**Application for Planning Permission for
Proposed House at Tuen Mun Town Lot No. 550 (TMTL 550), Tuen Mun, N.T.
(Application No. A/TM/601)**

Table 1: Responses to Comments from Government Departments on Planning Application No. A/TM/601 (13 November, 2025)

Revised Drainage Impact Assessment

Figure
7

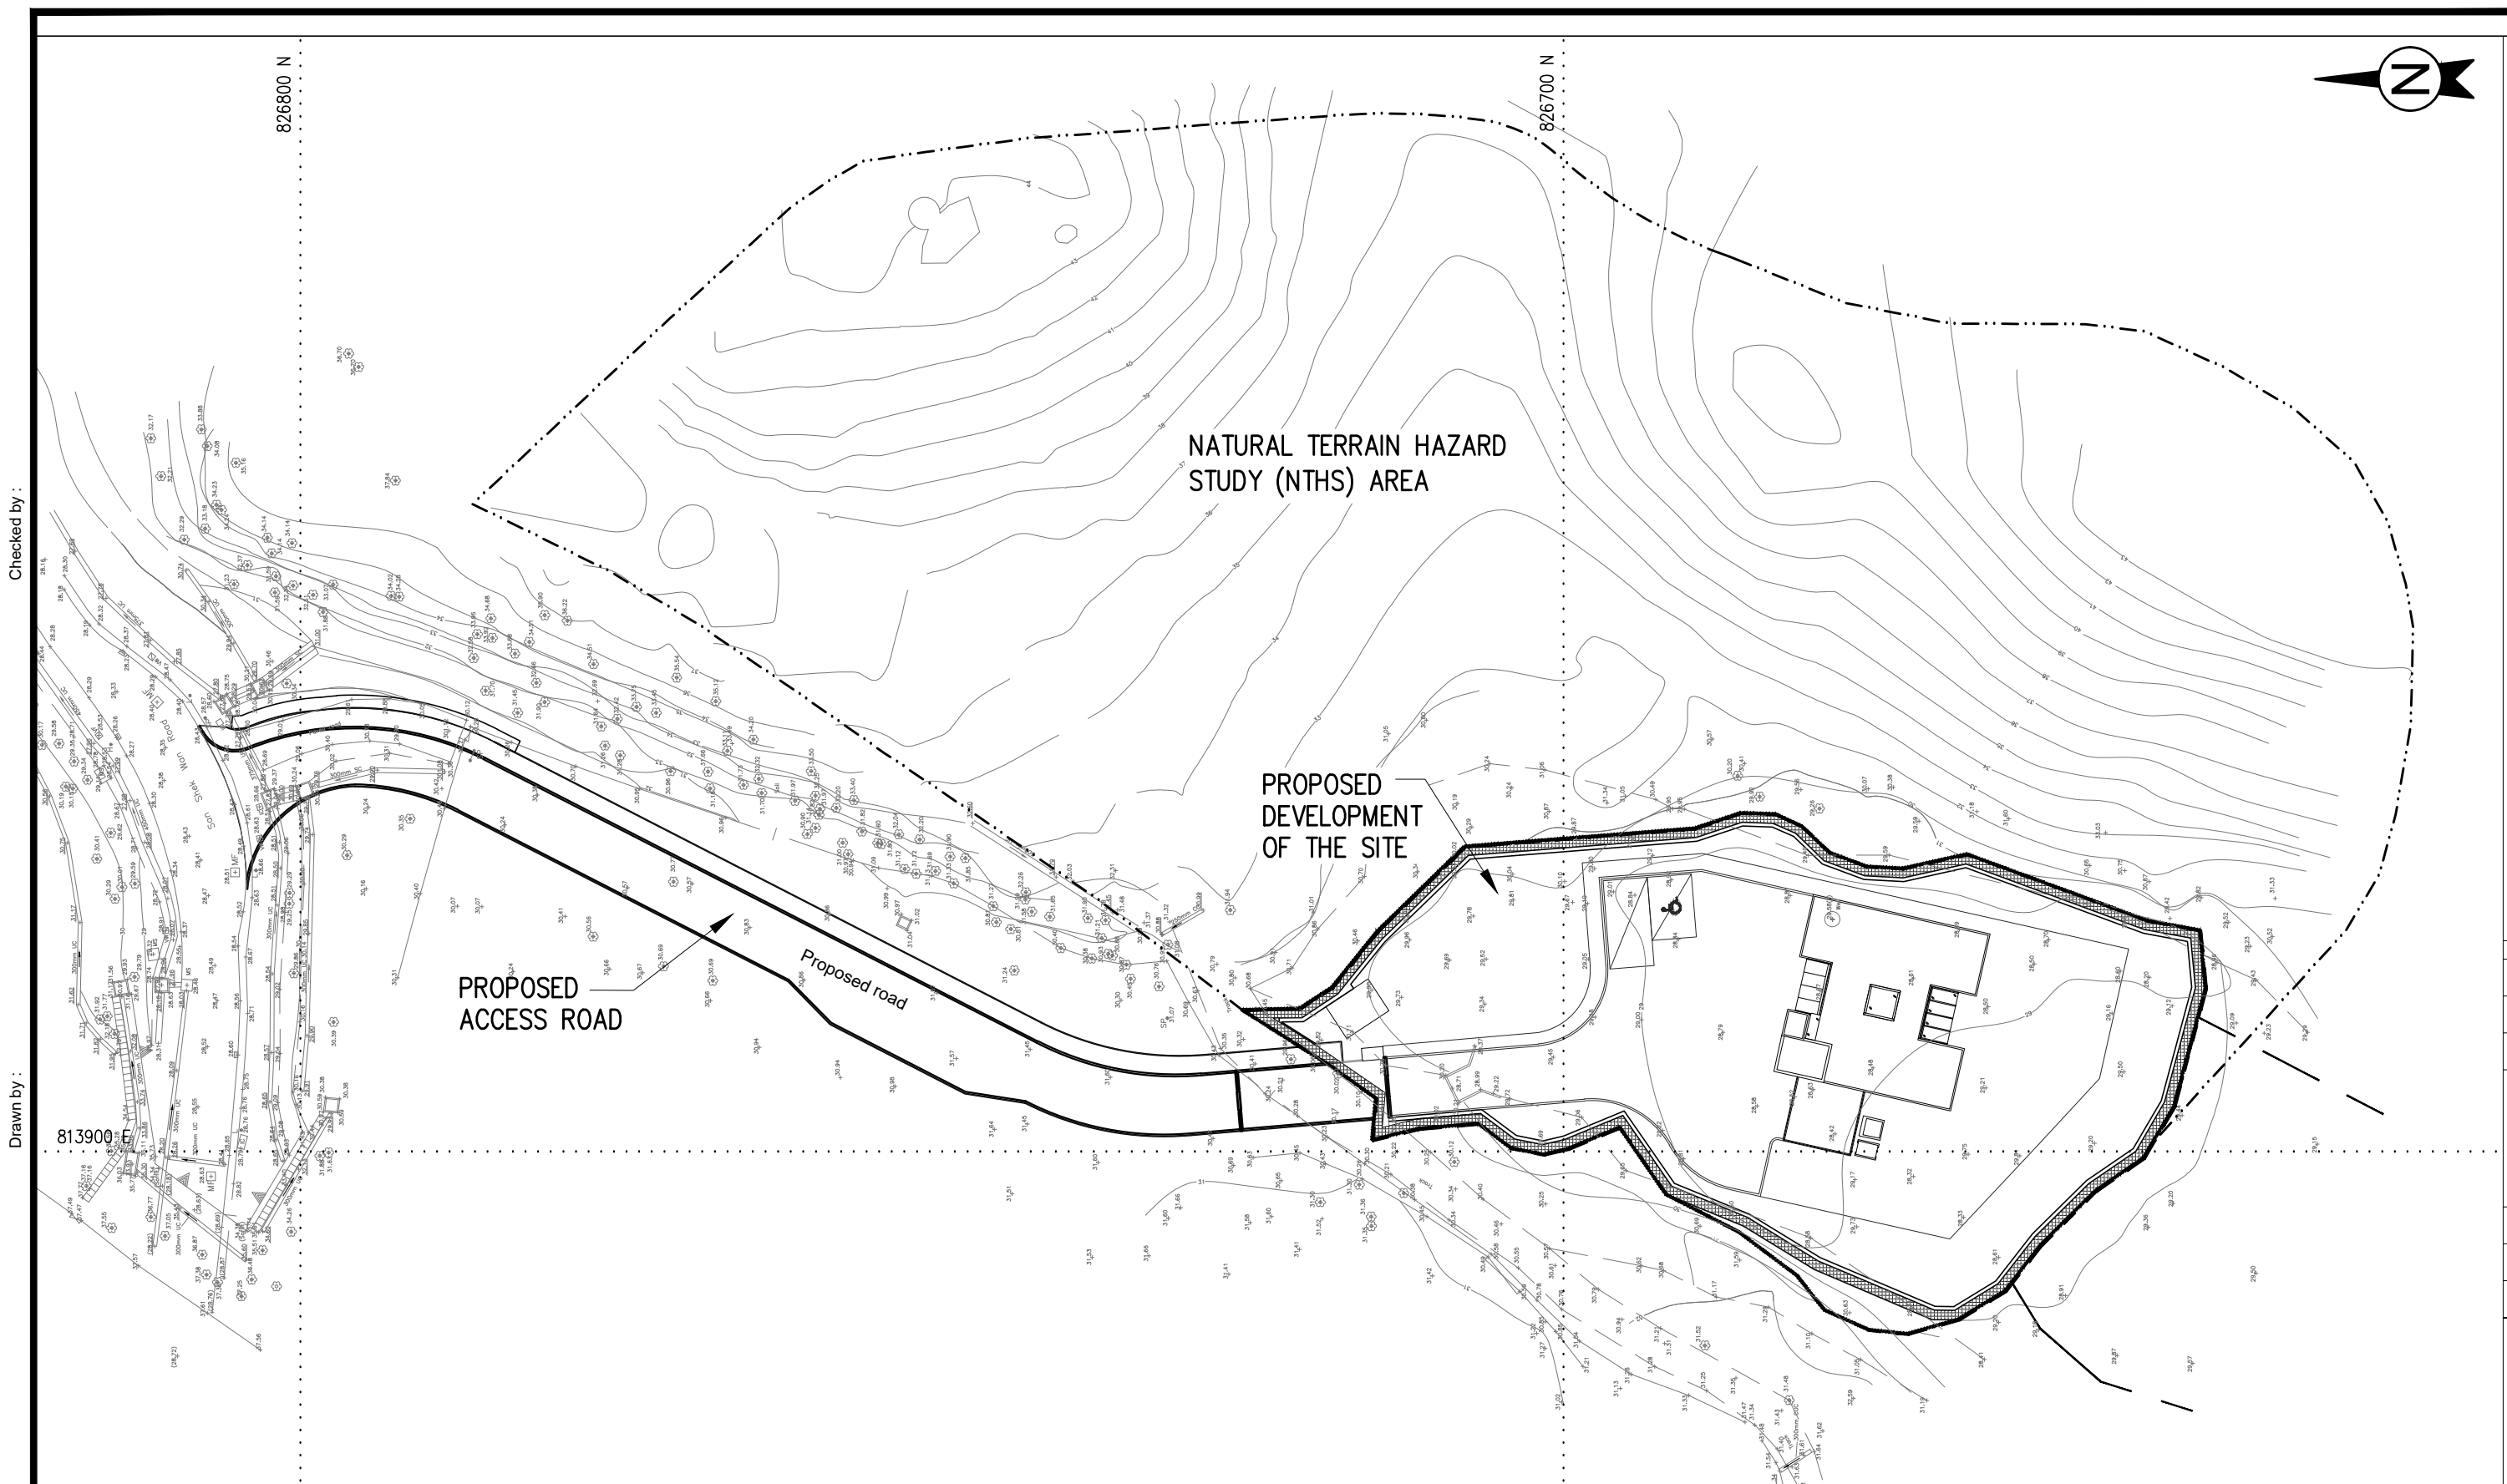
COMMENTS	RESPONSES
3. Geotechnical Engineering Office, Civil Engineering and Development Department (GEO/CEDD)	
(a) Section 4.2, Figure 7 and Figure 14 of the GPRR. It is noted that the applicant has committed, in the GPRR, to undertake a natural terrain hazard study (NTHS) and to implement mitigation measures, if necessary, as part of the proposed development. However, the proposed NTHS study area as shown in Figure 7 and Figure 14 are inconsistent. The applicant is reminded that the NTHS study area should include the entire upslope natural terrain catchment above the subject site. Please ask the applicant to clarify and amend the figure(s) accordingly.	(a) Figure 7 and Figure 14 are revised to include the entire upslope natural terrain catchment above the site (see the revised Figure 7 and Figure 14 of the GPRR report in Annex C).

SCALE	AS SHOWN	DATE	November 2025
CHECKED	ELK	DRAWN	TEAM
FIGURE NO.	Figure 1.1		REV
			-

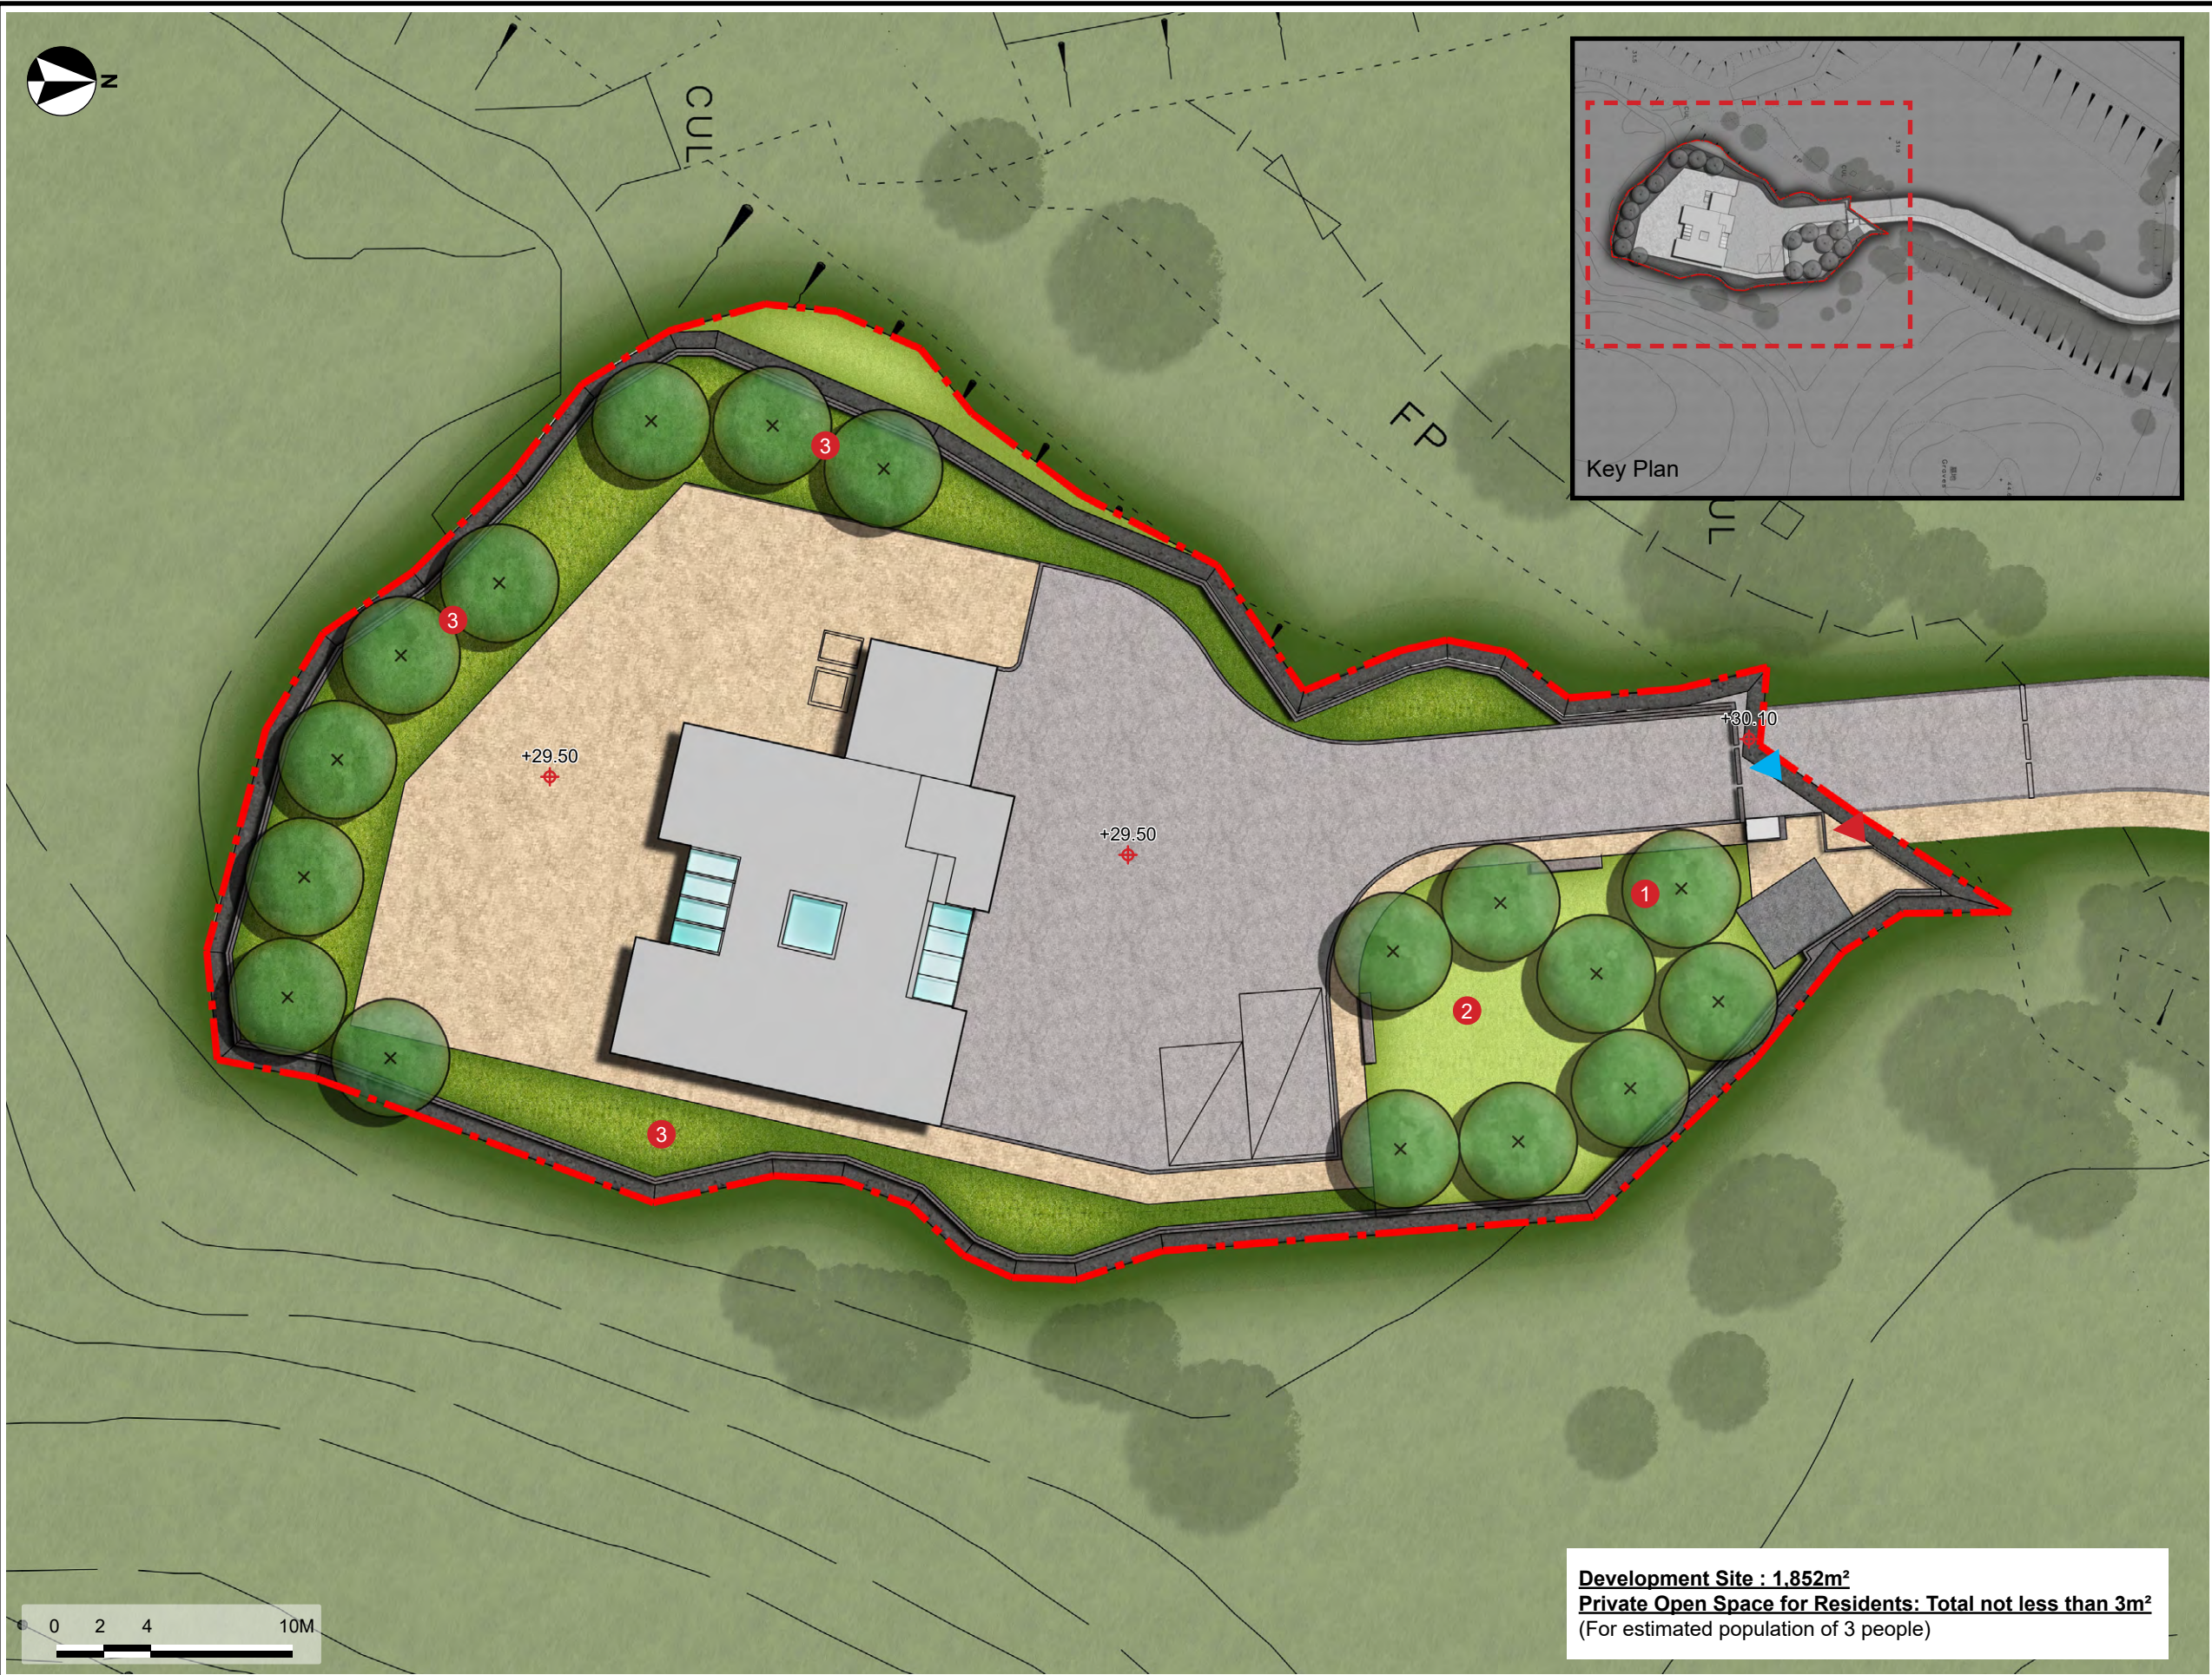
c. <u>Figure 1.1 & 1.2 (Landscape Plan)</u> i. It is observed that some grey and beige colors occupy a large portion of the application site that is connected to the pedestrian and vehicular entrance/exist, but they are not indicated in the legend table. Please review.	i. Relevant legend added (see Annex E).
ii. A discrepancy in the proposed soft-landscape treatment is observed among this figure, Section B-B', and paragraph 9.10. Paragraph 9.10 notes "<i>Hydroseeding on sloping area</i>." However, the Landscape Plan shows that the northern area adjacent to the application boundary is proposed for lawn planting, while Section B-B' indicates that the proposed lawn area is a slope. Please review.	ii. "<i>Hydroseeding on sloping area</i>." is a potential treatment on slope/retaining wall. Whilst there is no sloping area proposed within the application site, this sentence in para. 9.10 has been deleted. Section B-B' is cutting across the site showing the edge plantings, part tree planting in lawn in the north of the site can only be seen in far and largely screened by the house. These planting behind the house is added to Section B-B'. Existing sloping green is location outside the application site. Relevant text and figures of Landscape Proposal and Tree Survey Report have been revised (see Annex E).
